May 5, 2023

232 Danville Drive RE:

I previously reviewed the initial design for this project in September of last year. My comments and recommendations on the revised design are as follows:

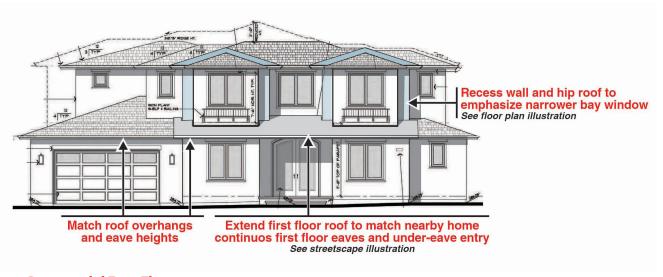
The immediate neighborhood has a preponderance of one story homes with a few homes having a partial second story. In almost all cases there is a strong first floor roof and eave line that emphasizes a one-story building form. This emphasis is enhanced by the use of traditional under-the-eave entries.

Recommended Front Elevation

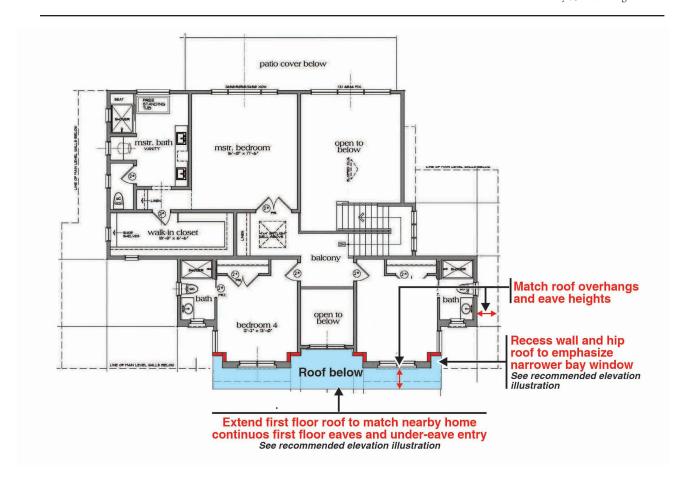
- 1. Modify the front wall of the two second floor bedrooms to reduce the very front wall facade width to produce bay windows see second floor plan illustration on the following page.
- 2. Match the overhang width and eave height along the central portion of the front facade and continue it across the home entry.

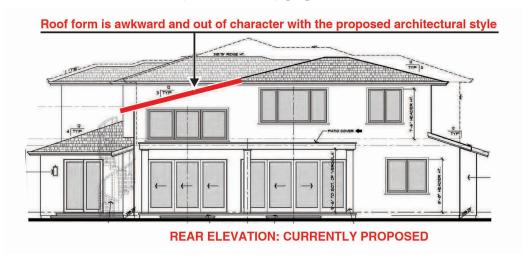
Implementation of the above two recommendations would reduce the second floor visual mass and better emphasis a strong first floor eave and roof line more in keeping with the other homes in the immediate neighborhood - see streetscape comparison below.
